**BEFORE THE PUBLIC UTILITY COMMISSION  
OF OREGON**

Docket No. LC 80

2023 Clean Energy Plan and Integrated  
Resource Plan.

OPUC Staff Opening Comments

**Figure 3. Staff’s preliminary hourly dispatch simulation of the Preferred Portfolio under Reference Case conditions**

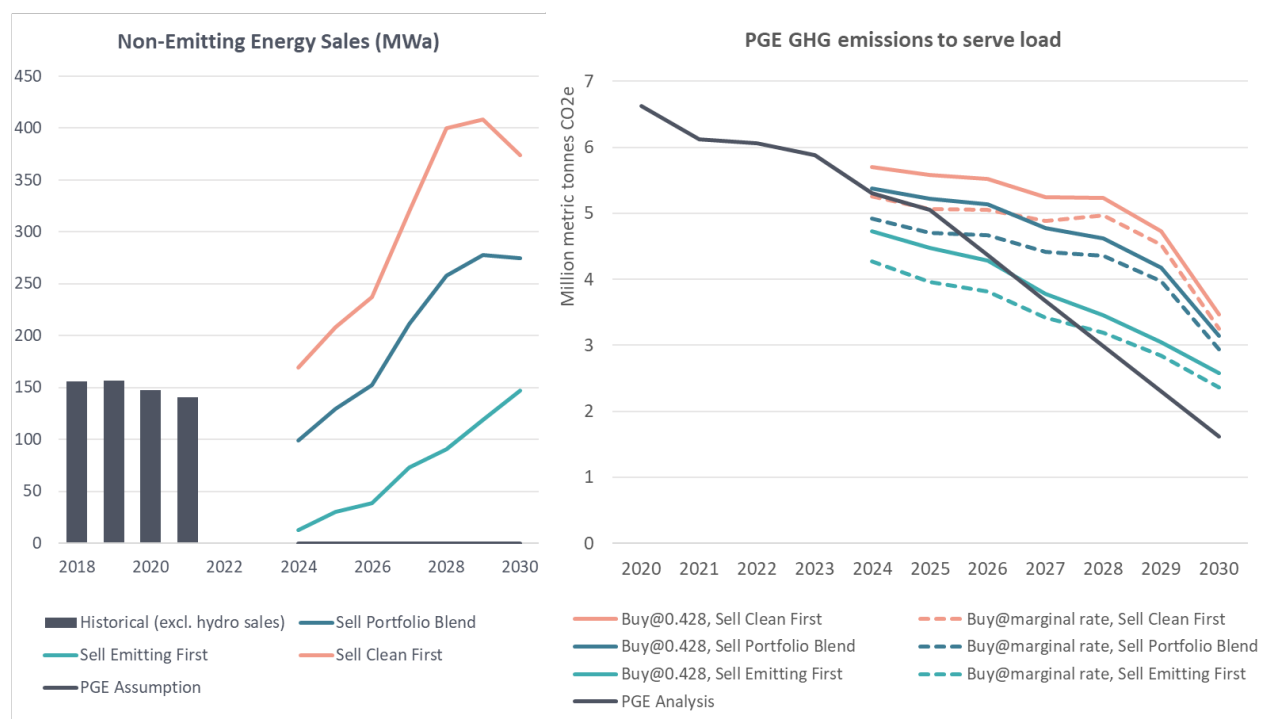
Staff’s preliminary analysis suggests under-accounting for non-emitting resource sales and underestimating portfolio GHG emissions may be a major vulnerability in PGE’s emissions reduction strategy (See Figure 3). Staff found that PGE’s GHG emissions estimates in the mid-2020s may be reasonable, but by the late 2020s, GHG emissions from the Preferred Portfolio could be well above PGE’s estimates even under the most optimistic assumptions regarding sales (i.e., that it is able to preferentially sell emitting generation).<sup>8</sup>

If PGE’s Preferred Portfolio is not physically able to meet its GHG targets, Staff is concerned that PGE may require more resources to meet the 2030 GHG targets than are in the plan. In particular, PGE’s plans may need more clean energy during hours when the portfolio is not long to the market—for example, some combination of energy efficiency, complementary renewable energy, and energy storage to bring more clean energy to PGE loads.

***Recommendation 2: Conduct hourly dispatch analysis of the Preferred Portfolio under Reference Case conditions; discuss the results and provide relevant workpapers with PGE’s Reply Comments. PGE should conduct this analysis in a manner that ensures load balance in each hour and that tracks hourly dispatch, variable costs, and GHG emissions by resource as well as hourly market purchases and market sales. PGE should also report annual portfolio costs and GHG emissions based on this simulation and that PGE provide transparency into how purchases and sales affect the GHG emissions associated with meeting load.***

**Figure 4. Cumulative NPVRR and GHG emissions results of portfolio analysis by CBRE portfolio26**

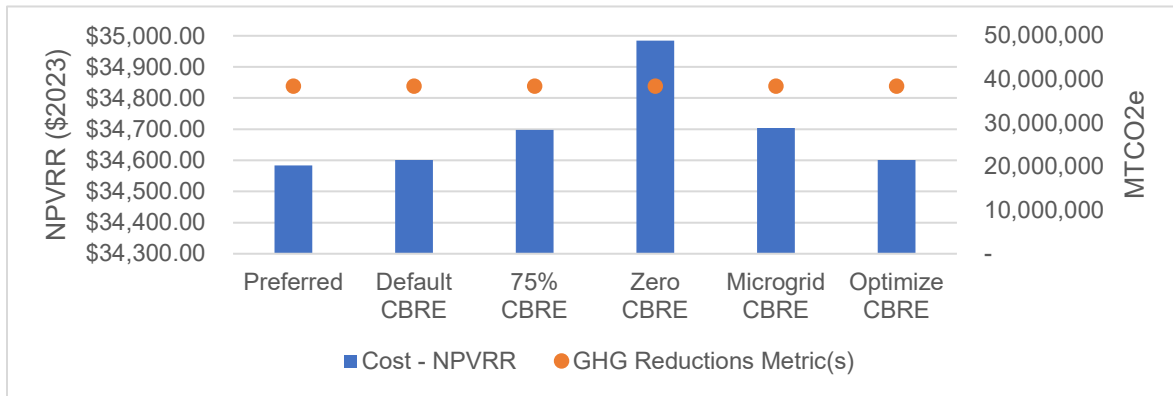
As shown in Figure 4, PGE's portfolio analysis suggests that acquiring CBREs up to the projected potential lowers overall portfolio costs compared to portfolios with reduced or no CBREs, including in the Optimize CBRE run. While PGE identified a meaningful CBRE potential level and useful portfolios to test, this analysis does not appear to provide any insights about CBREs.

First, the portfolio analysis does not appear to provide insights into the ability of CBREs to offset thermal resources. PGE’s portfolio optimization allows CBREs to compete with supply side resources, as illustrated in Figure 4, the emissions profile of the portfolio with zero CBRE acquisition, and the portfolios that acquire all available CBRE result in identical annual emissions.

During the development of near-term CEP guidance, Staff believed that including CBREs in portfolio analysis would help satisfy the HB 2021 requirement to, “[e]xamine the costs and opportunities of offsetting energy generated from fossil fuels with community-based renewable energy.”<sup>27</sup> PGE’s modeling approach answers part of this question by allowing CBREs to help contribute to GHG emission reductions, the Company does not appear to have provided analysis that allows the existence of CBREs to directly impact the dispatch of emitting resources or understand how that changes costs, risks and benefits of the portfolio. Staff will consider this issue when reevaluating the Commission’s planning and procurement policies in 2024, but Staff also expects PGE to submit a supplemental analysis with its reply comments that better addresses the statutory requirement.

***Recommendation 7: In its Reply Comments, PGE should provide a supplemental analysis that satisfies the HB 2021 requirement to examine the costs and opportunities of offsetting energy generated from fossil fuels with community-based renewable energy.***

**Figure 6: Comparison of PGE's forward market prices from previous IRP filing to current CEP/IRP<sup>41</sup>**

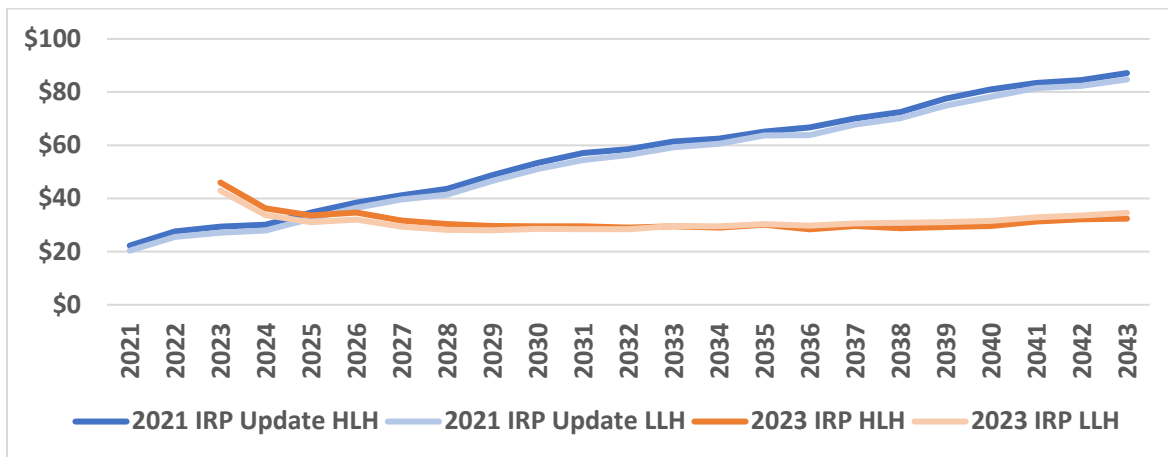
At the June 13, 2023, Special Public Meeting and in Round 0 Reply Comments, PGE stated that the avoided costs of this IRP/CEP will be used by ETO in the budgeting once the IRP/CEP is acknowledged.<sup>39</sup> However, Staff has not seen evidence that appropriate avoided costs are available as an outcome of this IRP for the proper valuation of energy efficiency. It is unclear how PGE evaluated the benefits associated with carbon reductions and avoided clean energy purchases from EE resources. PGE's IRP/CEP assumes no additional cost of carbon compliance in Oregon over the planning horizon. In response to Staff's questions on including clean energy in capacity and energy values, the Company cited the use of a four-hour battery in place of simple-cycle combustion turbines as a capacity resource and indicated that additional analysis needs to be done to account for clean energy in deriving energy values.<sup>40</sup>

**Figure 7. Staff’s analysis of PGE’s transmission rights implied by the Preferred Portfolio through 2030**

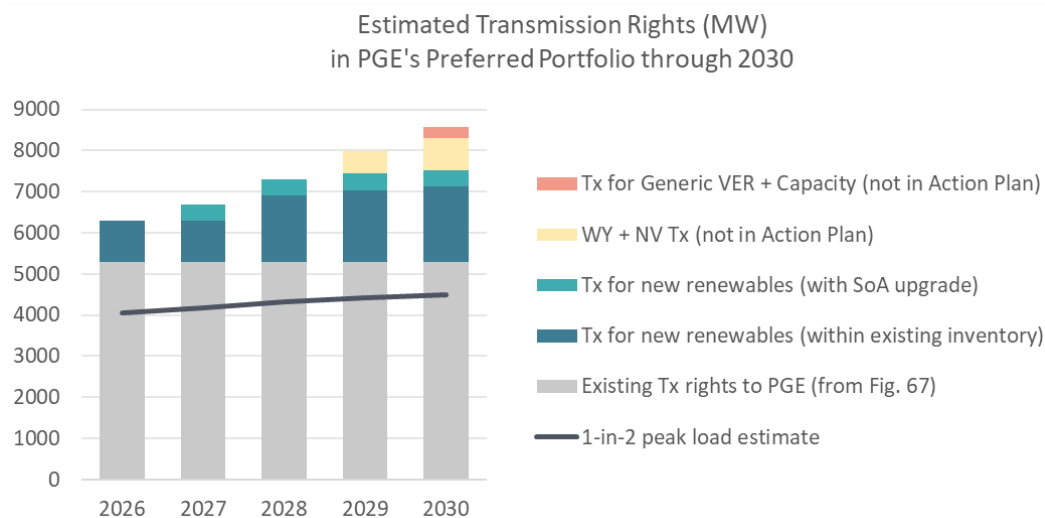
Figure 7 shows Staff’s estimate of the total amount of transmission rights implied by PGE’s Preferred Portfolio through 2030, broken out by existing merchant rights, rights for new renewables that are within PGE’s estimates of BPA’s long-term firm and conditional firm inventories, rights that could become available with PGE’s proxy transmission additions, and additional transmission rights that could be needed for off-system renewable and capacity additions.<sup>44</sup>

Staff is also concerned that the transmission additions in the Preferred Portfolio changed so dramatically between the filed IRP and the recently filed Addendum. Specifically, the Wyoming and Nevada transmission additions through 2030 increased from 255 MW in the filed IRP to 800 MW in the Addendum, driven by updates to PGE’s load forecast. Despite how sensitive the transmission needs appear to be to the load forecast, PGE does not directly address the risk that it may have severely underestimated or overestimated future transmission needs within the plans.

**Figure 8. Staff’s analysis of PGE’s transmission rights implied by the Preferred Portfolio through 2040**

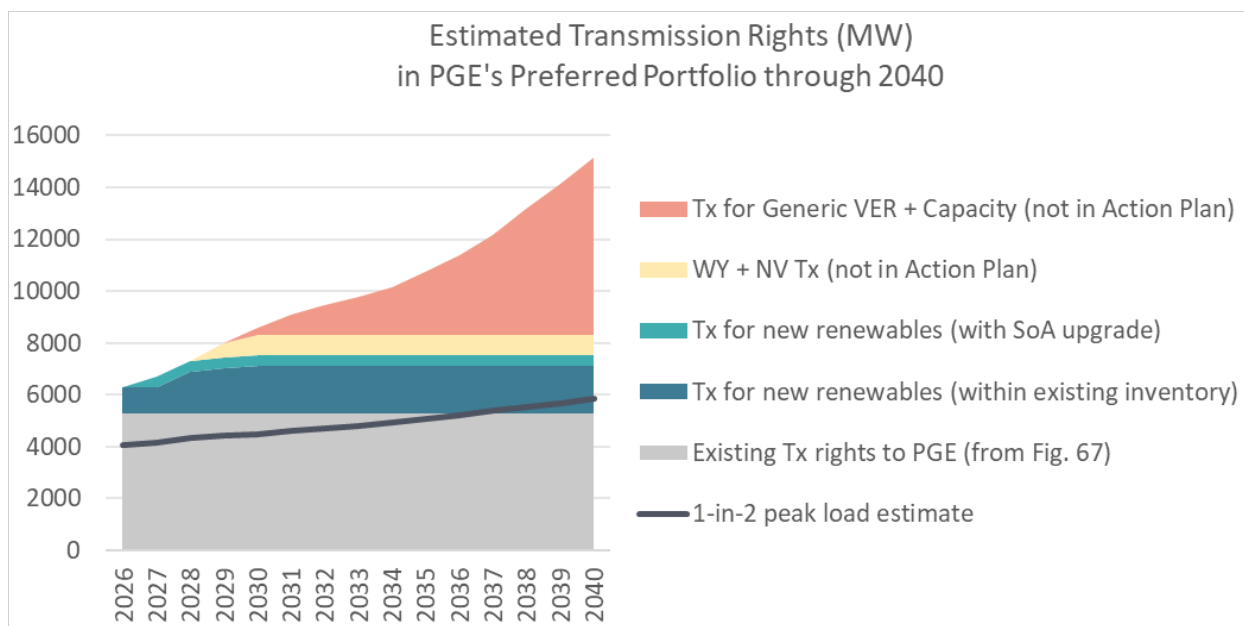
Figure 8 shows Staff’s estimation of PGE’s transmission rights implied by the Preferred Portfolio through 2040.<sup>51</sup> Staff notes that the total transmission rights into PGE’s system will far exceed the peak demand if PGE does not materially adjust its long-term transmission strategy in the context of HB 2021.

This raises several questions from Staff’s perspective: How will PGE demonstrate that accumulating these transmission rights is in customers’ interests or use excess transmission rights to directly benefit customers? What alternatives should PGE analyze to reduce costs to customers and to avoid unnecessarily over-constraining BPA’s transmission inventory? Alternative strategies could involve relying to some extent on short term firm or non-firm transmission, allowing new resources to use PGE’s existing transmission rights or to share transmission rights with other resources, allowing resources to secure transmission rights to less constrained points on the transmission system and limiting transmission rights across constrained paths based on what is needed for load service, and/or joining an RTO. All of these options could bring about new risks and Staff believes that a more rigorous understanding of these risks will support more informed planning decisions related to transmission.

**Figure 13. Wind ELCC comparison between 2019 IRP Update and 2023 IRP**

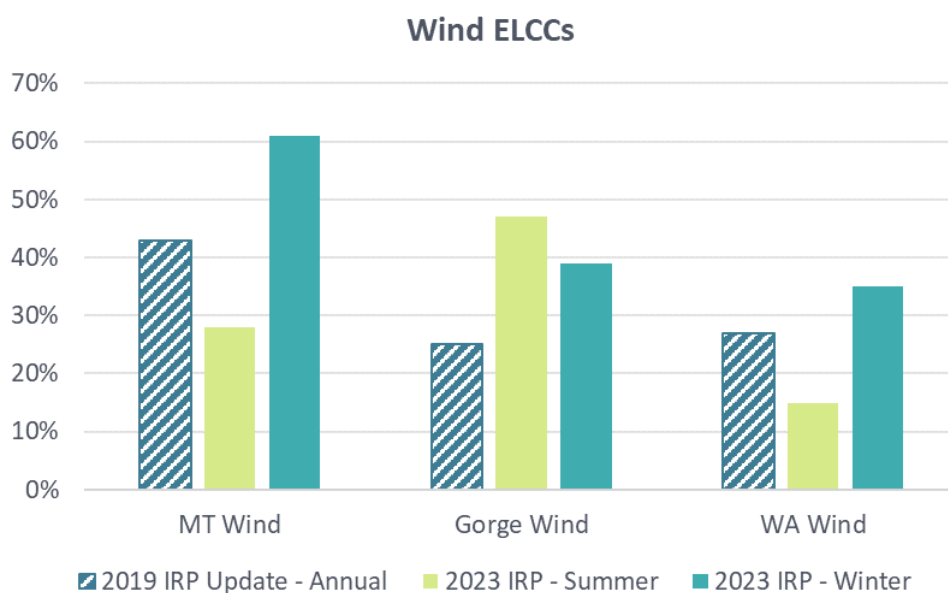
Staff is concerned that PGE’s analysis may be overestimating the capacity contribution of Gorge Wind in the portfolio analysis.

The Gorge Wind ELCC appears to be much larger than in the 2019 IRP Update (see Figure 13) and it is not clear to Staff why this would be the case. PGE indicates in its response to OPUC Data Request No. 71 that the wind shapes in Sequoia were developed using NREL’s System Advisor Model. Staff requests that PGE explain why Gorge Wind ELCCs have increased so much since the 2019 IRP Update.

Staff is also reviewing the tuned ELCCs provided in Appendix K. Staff requests that PGE provide additional discussion of why there are such large differences between the tuned ELCCs and the ELCC curves used in portfolio analysis.
